VOLLMER ROAD (NORTH)

GRADING AND EROSION CONTROL PLANS

NOVEMBER 2021

Cursorly redlines - see comment letter

VOLLMER ROAD
STA 57+50 TO STA 67+50

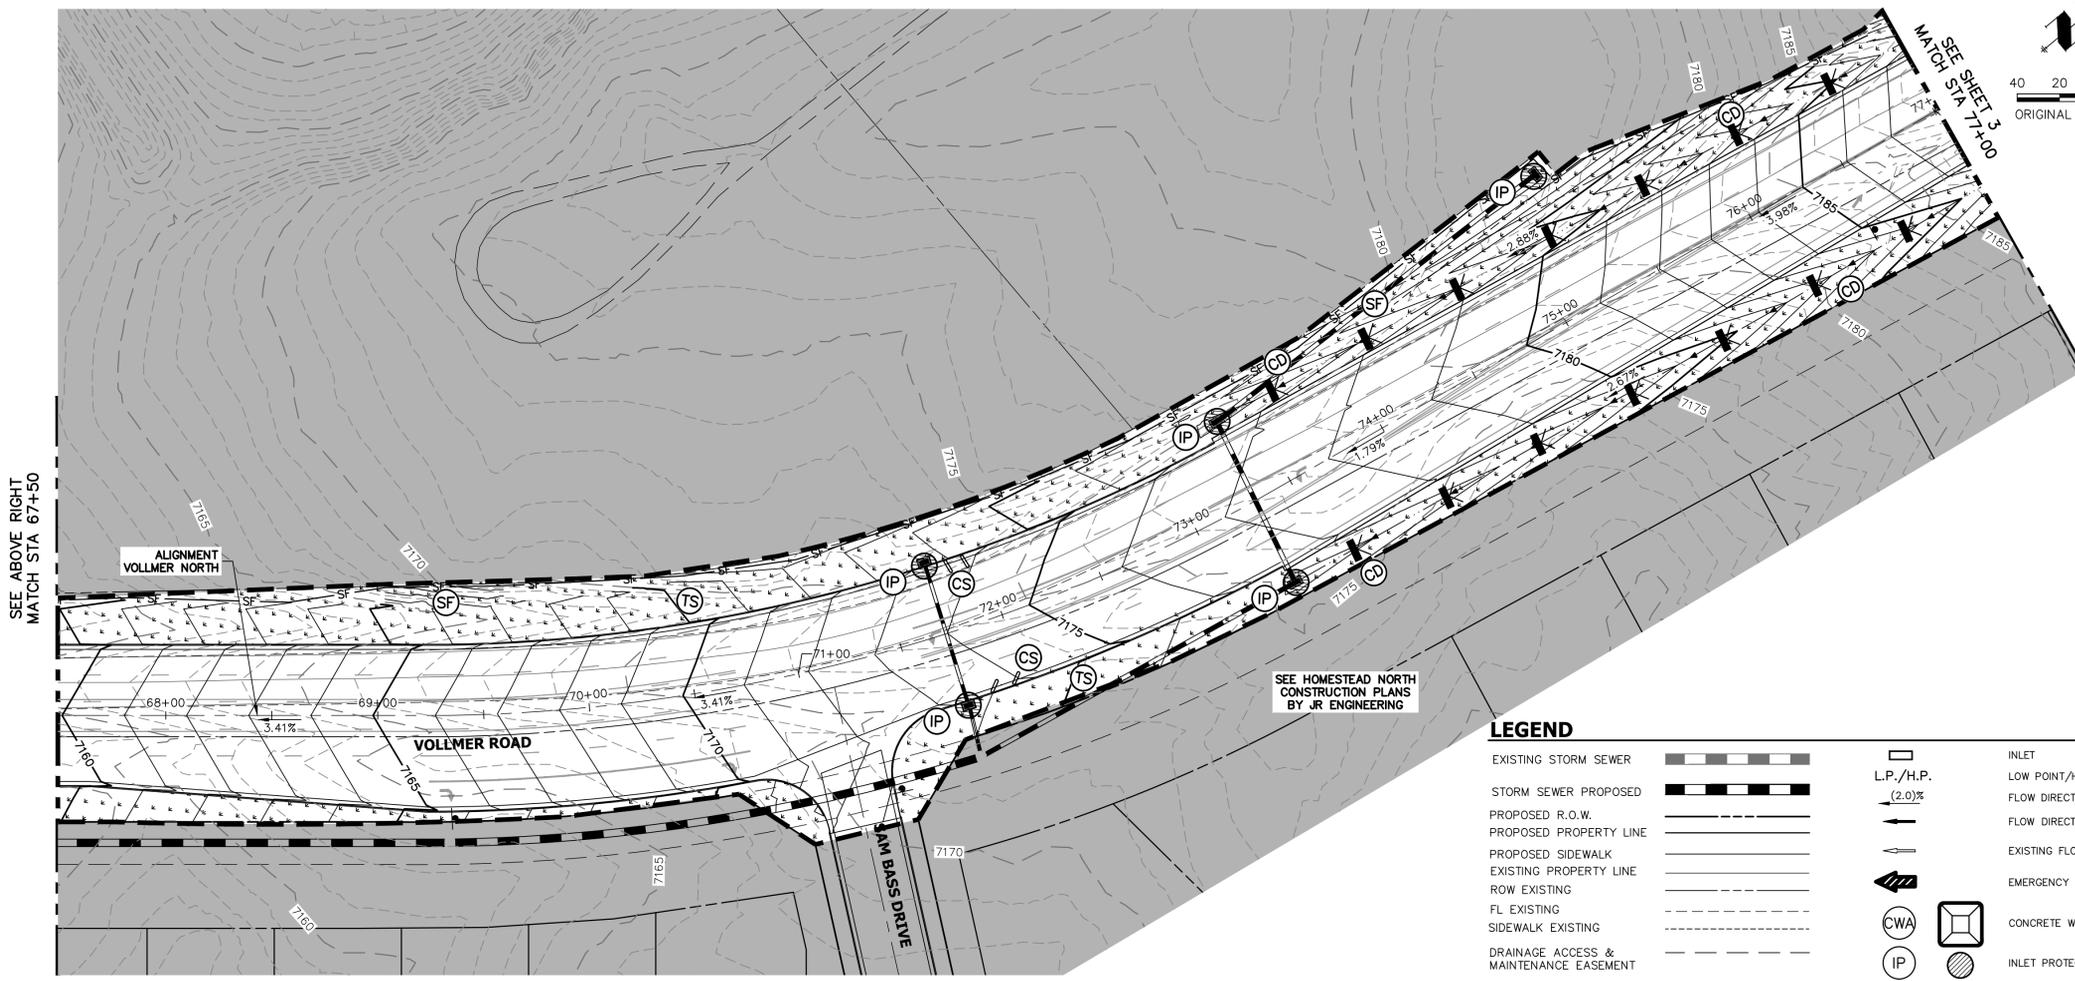
Initial, interim and final plans will be required.

VOLLMER ROAD
STA 77+00 TO STA 85+76

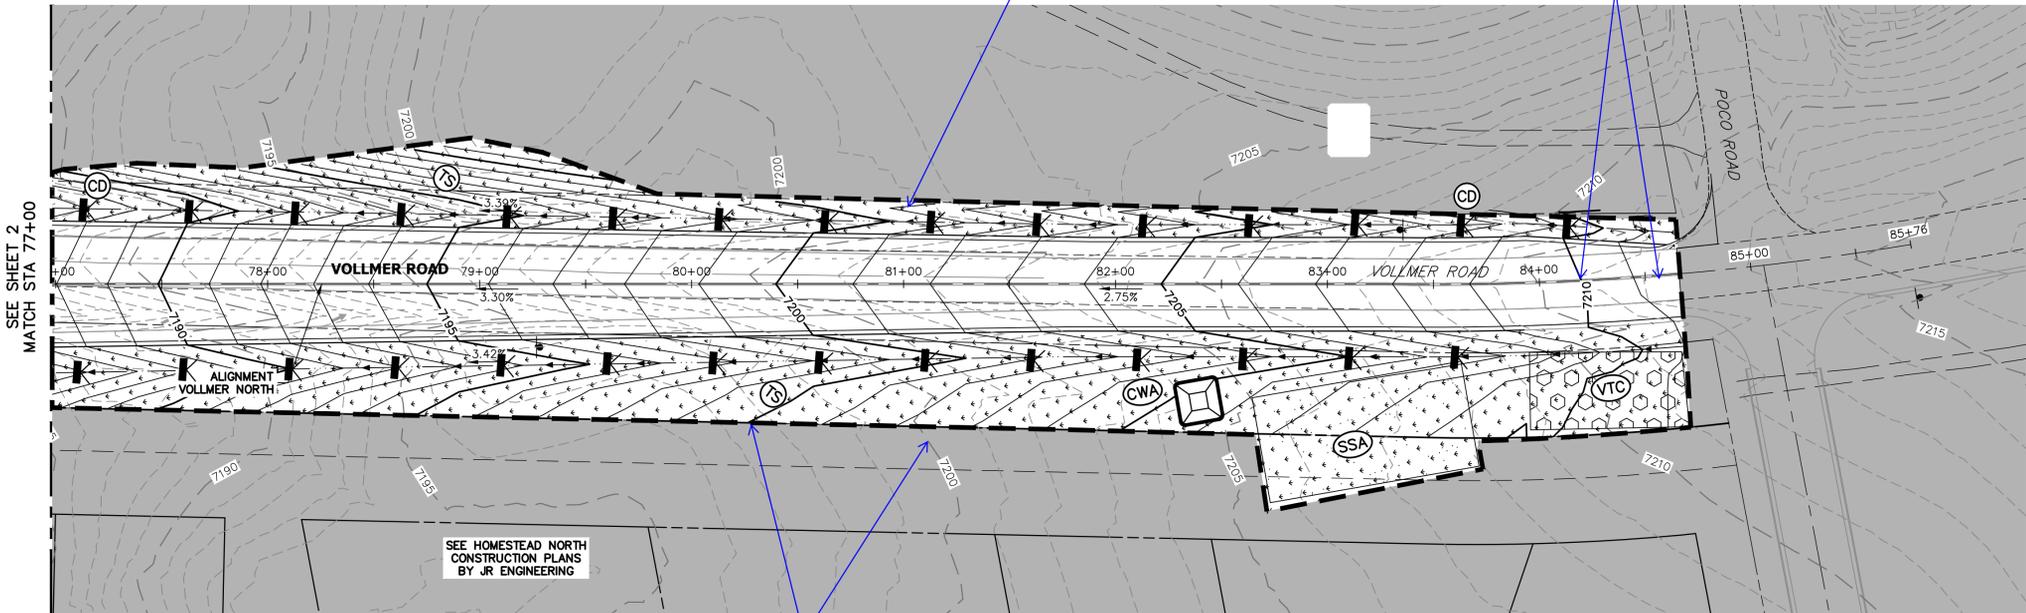
contours aren't
tying in - show all
grading.

Verify grading per
cross-sections (is a
berm/double ditch
needed here?)

show crown
